Application for Modification of Major Project Approval 10_0204

Modification No. 2

Montefiore Street, Catherine Hill Bay

Coastal Hamlets Pty Ltd

Image 1: Location of section of road 23 proposed to be deleted.

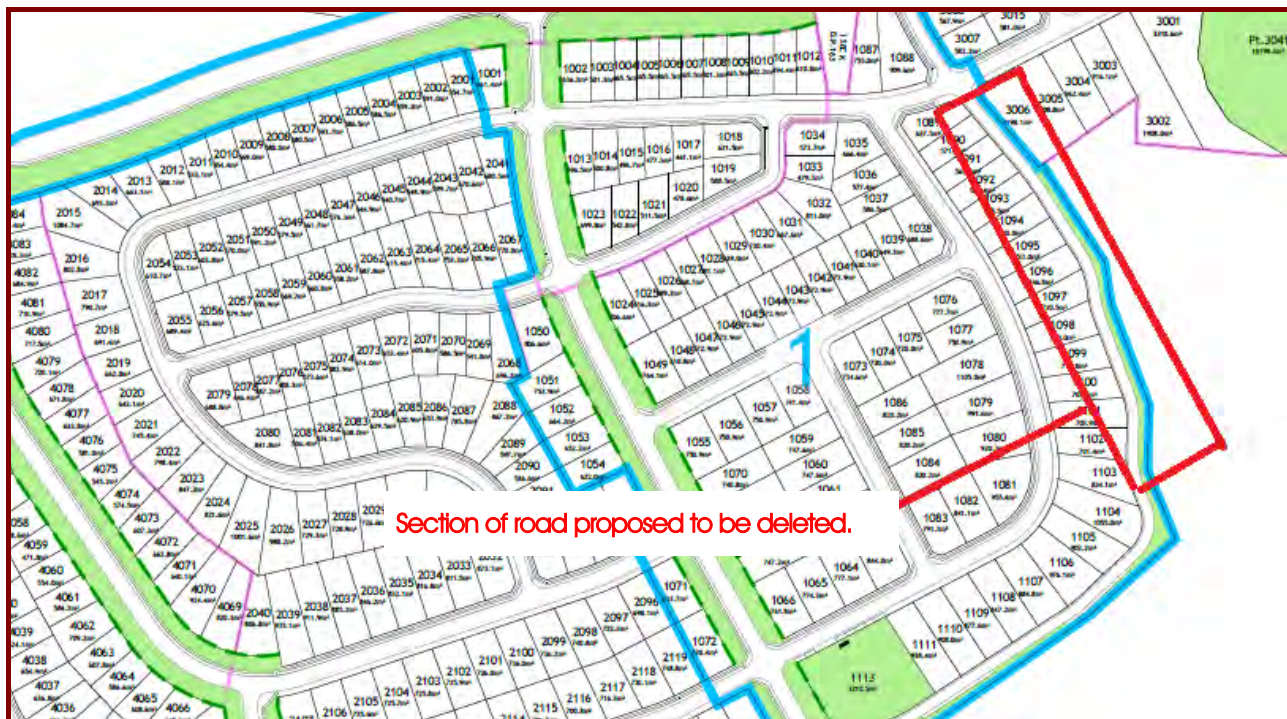
As approved, Road 23 in Stages 1 and 2 of the subdivision provides a perimeter road to the northeast of Stage 1 as shown in **Images 1 and 2** below.

It is now proposed to reduce the length of the perimeter road by deleting all of Road 23 from Lot 1101 north. The need for fill and/or a retaining wall was created by the need to achieve design road grades. Without the need to achieve the grades the rear of the lots can remain mostly at existing ground level and drainage can be achieved without the creation of a trap low point. An overland flow path through Lot 1096 will convey this water into the street drainage system. A design that avoids the problems caused by the perimeter road across the gully is provided as **Attachment B** and includes a comparison with the approved layout.

Image 3: The approved road 23 with design contours for the site and adjoining contours.

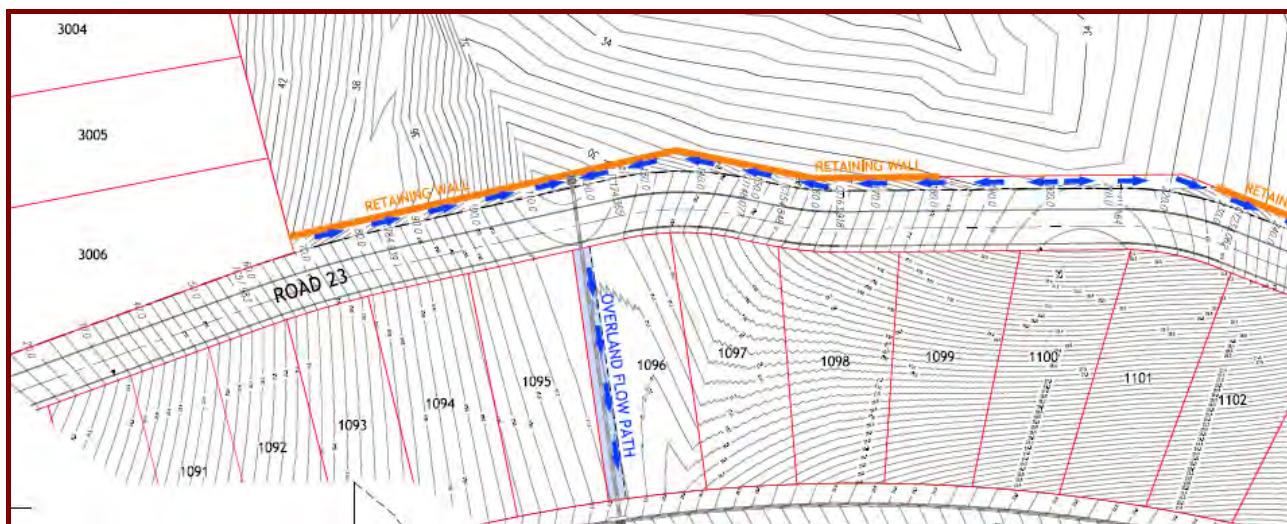
Due to the significant slopes along the road alignment and allowing for the road to be at maximum grade, to construct Road 23 as approved, either a retaining wall or fill is required on adjoining land. Plans showing the retaining wall and fill options are provided as **Attachment A**. Any such works incorporating a retaining wall create a trap low point for gully drainage, refer to **Image 3** above. A suitable retaining wall would have a height of 9 metres and would be extremely difficult to design and construct without footings on adjoining land.

Image 4: Extent of fill on adjoining land required to build Road 23 as approved.

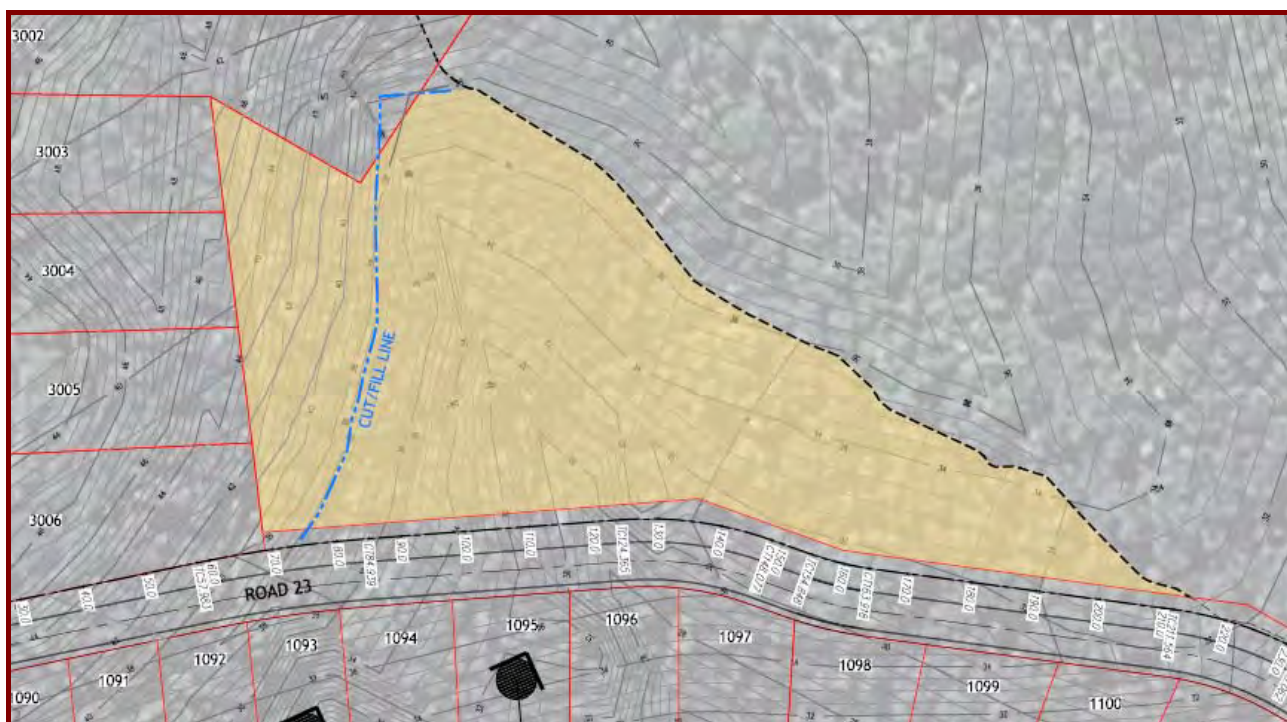
In order to remove the trap low point, a solution would be fill within the adjoining lands. This option would be to fill some 4000 m² of adjoining conservation land. This option would still result in a retaining wall adjacent to Lot 3006.

Plan of: STAGE 1
COMPARISON OF REVISED ROAD AND LOT LAYOUT

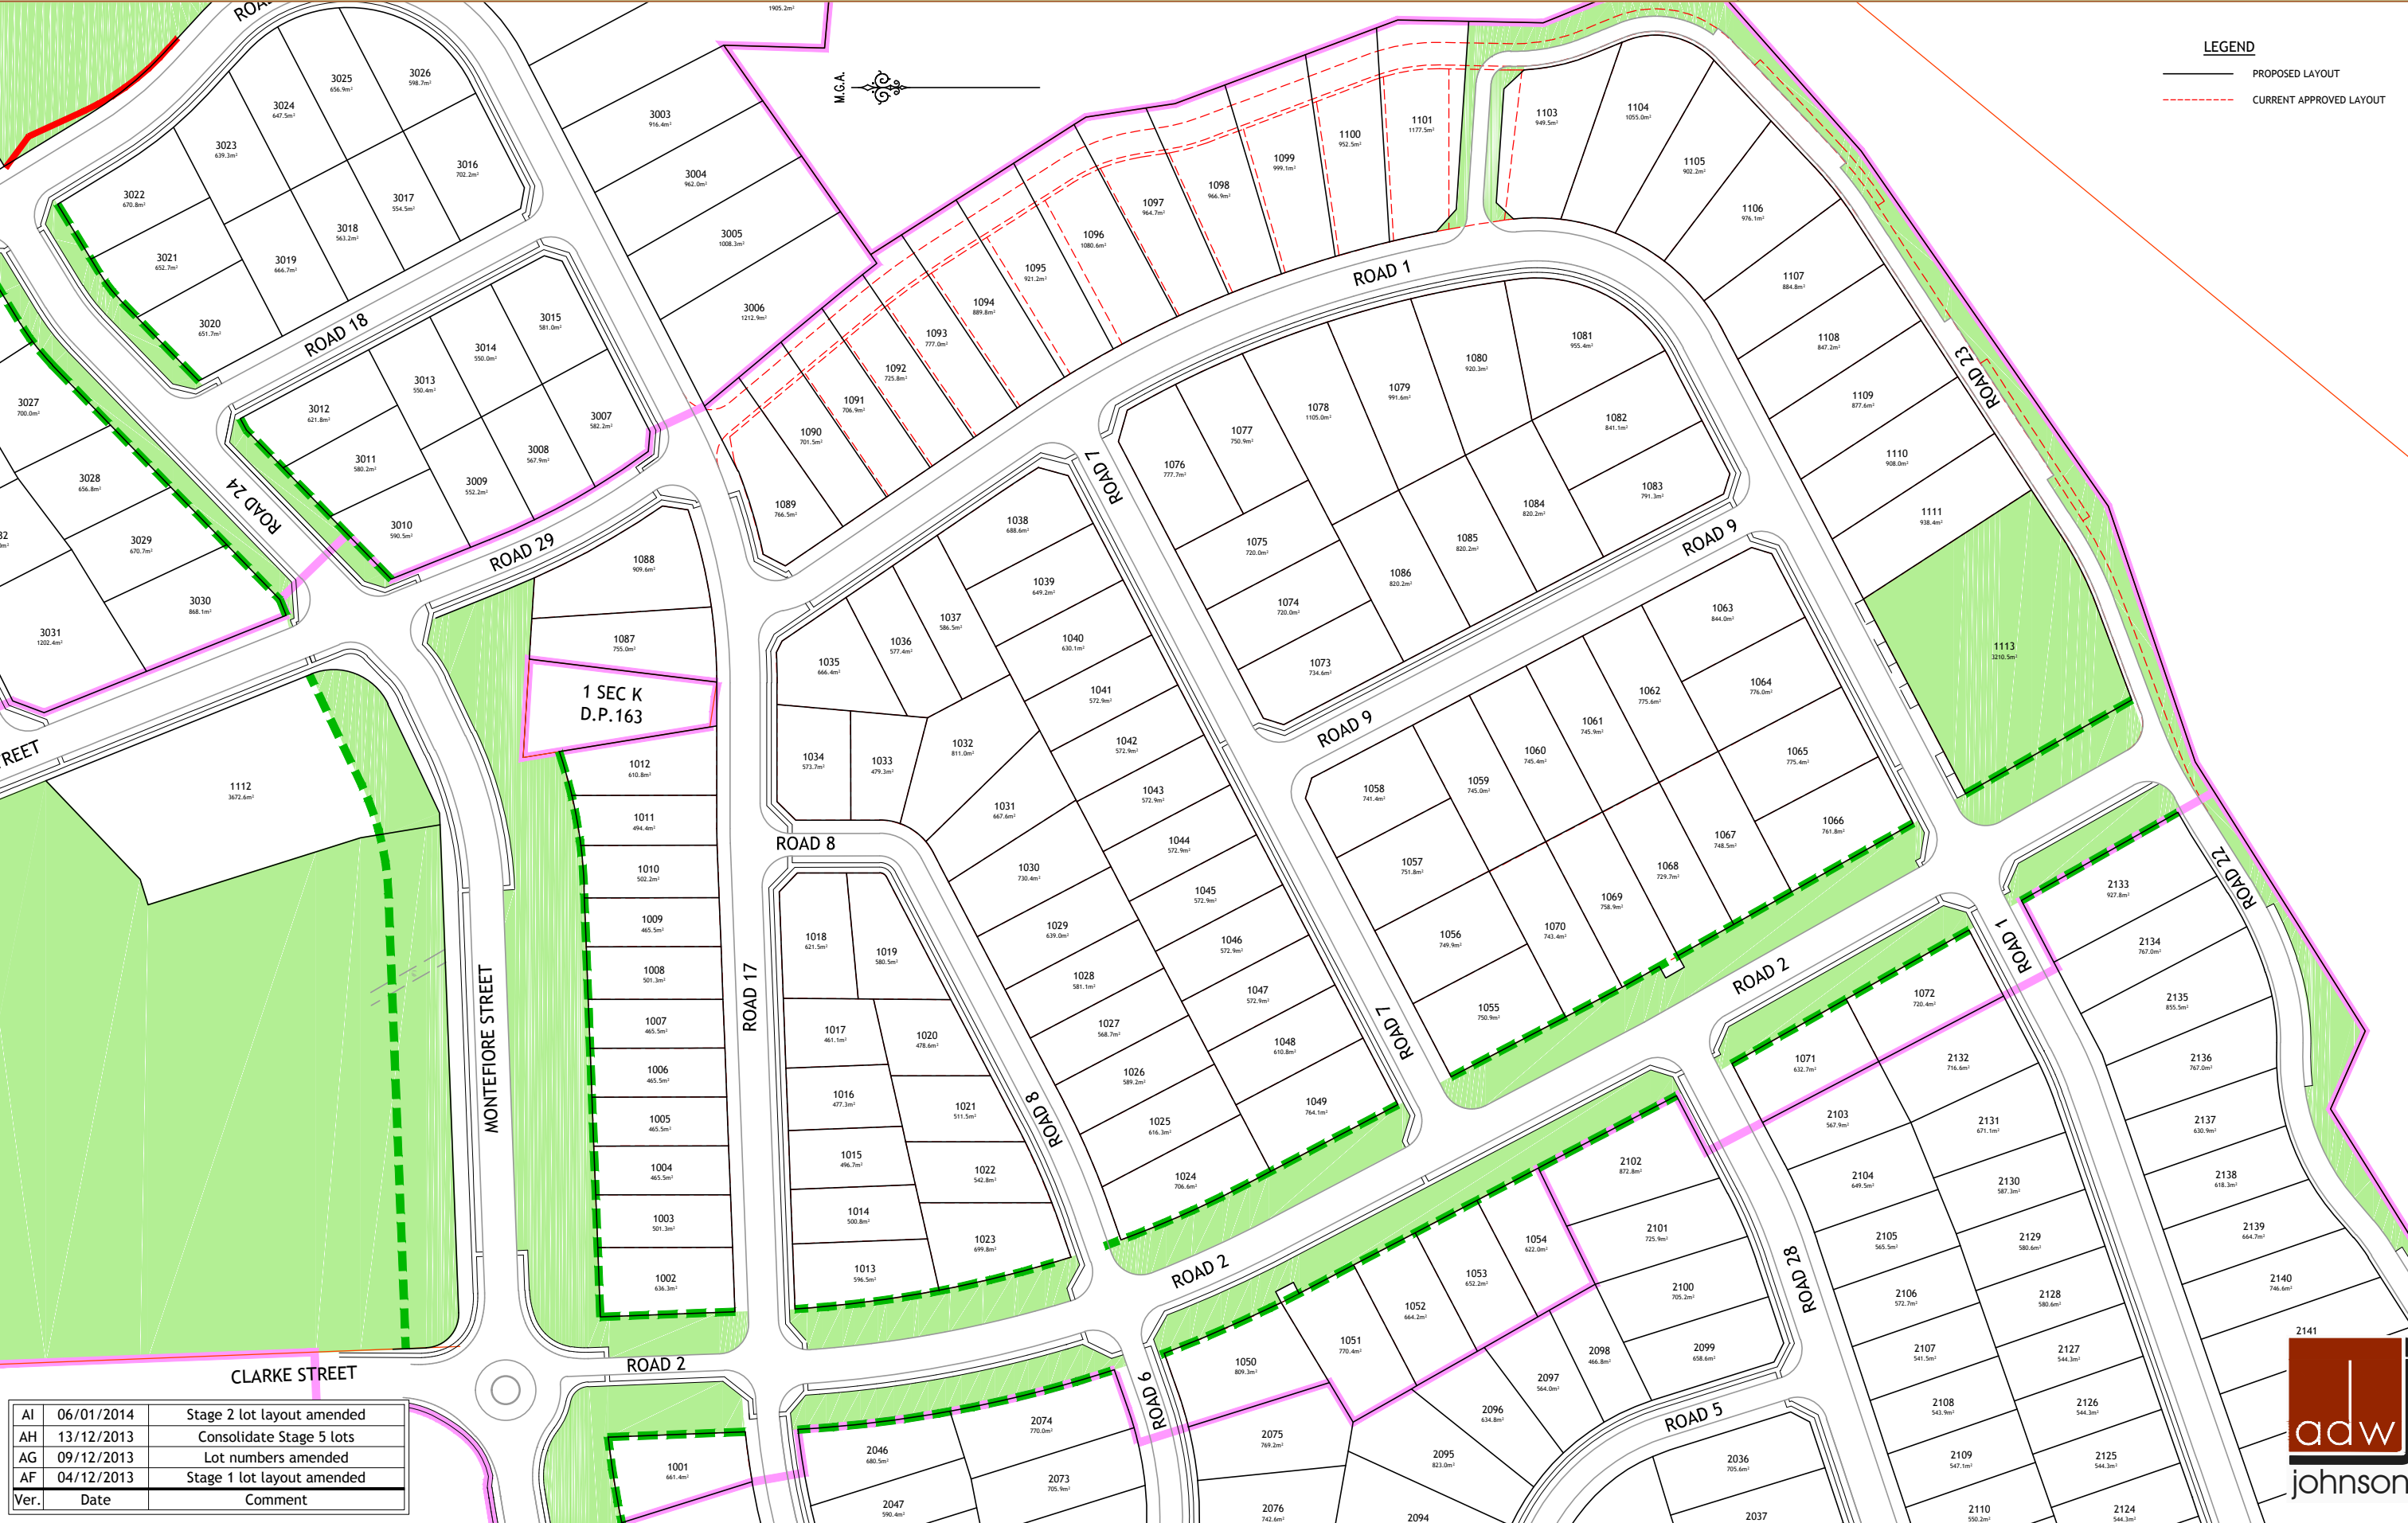
The design change affects Stage 1. Stage 1 is reduced by one lot from 113 lots to 112 lots including 110 residential lots, 1 lot for the neighbourhood shops and one lot for a drainage basin. One lot has been removed due to the need to link Road 1 to the remaining length of perimeter Road 23. The lot that was approved as 1102 becomes part of Road 23. The lot boundaries are slightly shuffled to incorporate this change and the need for the additional flow path in Lot 1096. The changes in lot boundaries can be seen on the plans at **Attachment B**. Lots 1089 to 1101 are extended by the width of the previous road along their rear boundary. The additions to the lots will not be built on as these areas are required for bushfire asset protection zones for lots 1092 to 1101. This will result in less impact to conservation lands adjoining these lots.

Road 23 is currently approved as a two way, 10.5 metre and variable road reserve with a 6 metre wide pavement. To accommodate road design standards it is proposed that Road 23 be slightly redesigned. There were issues in achieving the required road grades and parking, south west of proposed Lot 1102. In this location retaining walls located on the boundary will be required, but can be minimised if the road width is reduced to 4 metres. At 4 metres width the road is only suitable for one way traffic, proposed to run from south west to north east. This will maintain access as required by the IHAP principles. The 10.5 metre width road reserve will be maintained.

Plan of: STAGE 2
COMPARISON OF REVISED LOT LAYOUT

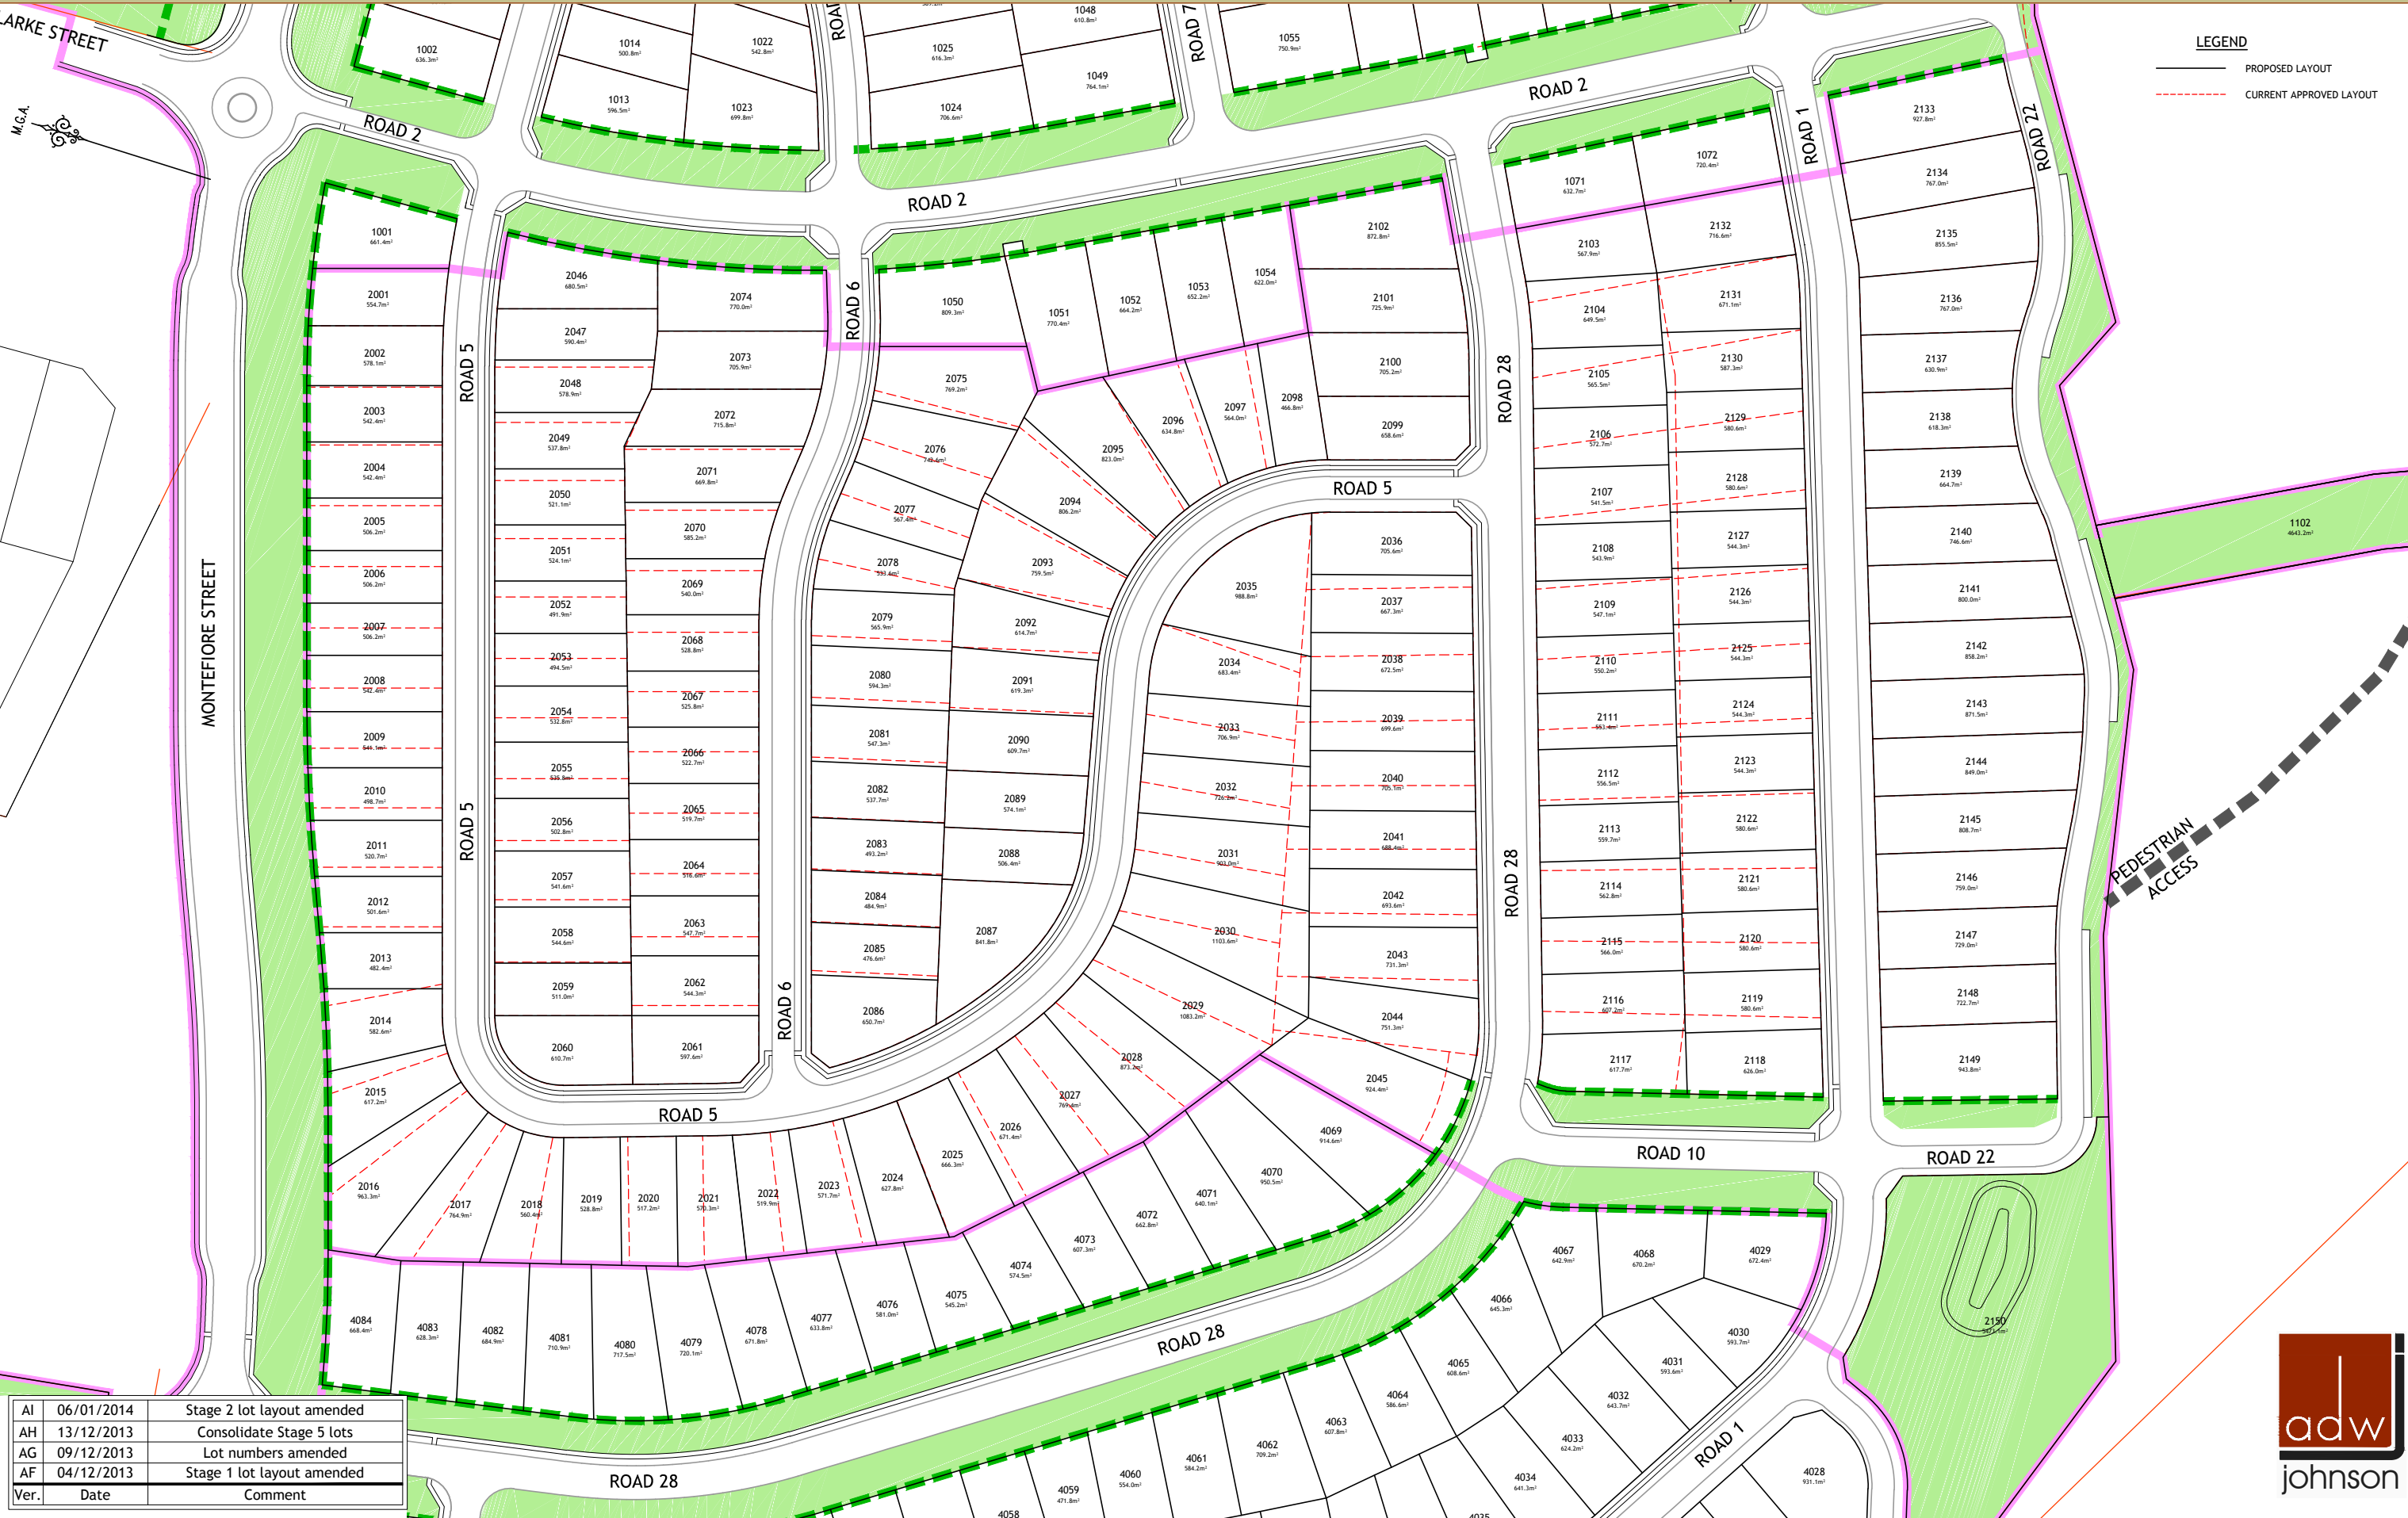
Reconfiguration of stage 2 lots will create an additional 13 lots.
